**Inland Empire Utilities Agency**

**RE: CEC Docket No. 14-AAER-1, APPLIANCE EFFICIENCY PRE-RULEMAKING**

IEUA has reviewed both the CEC draft staff report and the Alliance for Water Efficiency's (AWE) summary recommendations (attached). ***IEUA supports the CEC staff recommendation for proposed faucet, toilet, and urinal rulemaking.***

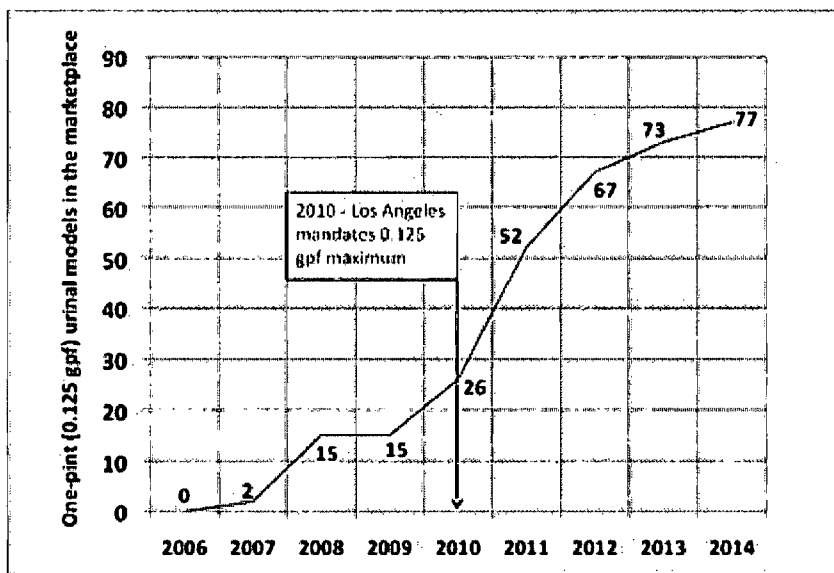
AWE recommends that further regulatory consideration of 0.125 gpf urinals be tabled for at least 3 years until field experience and drain line research can provide insight regarding the efficacy of that consumption level. To our knowledge, a study of this kind is not yet underway, and AWE recommends that the CEC investigate using EPIC funds for this needed research. When sufficient and satisfactory data and field experience become available, AWE recommends that the CEC then reconsider the 0.125 gpf threshold in its future rulemaking.

- Urinals flushing at 0.125 gpf were introduced to the marketplace in 2006. Response was initially very slow and the marketplace had limited product availability. It was only in 2010 that product selection was sufficient to gain attention, and in October, 2010 these pint urinals were required for new installations by the City of Los Angeles. (Their experience to date with these fixtures remains undocumented.) Today, only 77 (about a third of all high-efficiency urinal models) certified to the WaterSense specification are at the 0.125 gpf threshold. See the chart below for information on the growth of these models<sup>2</sup>.
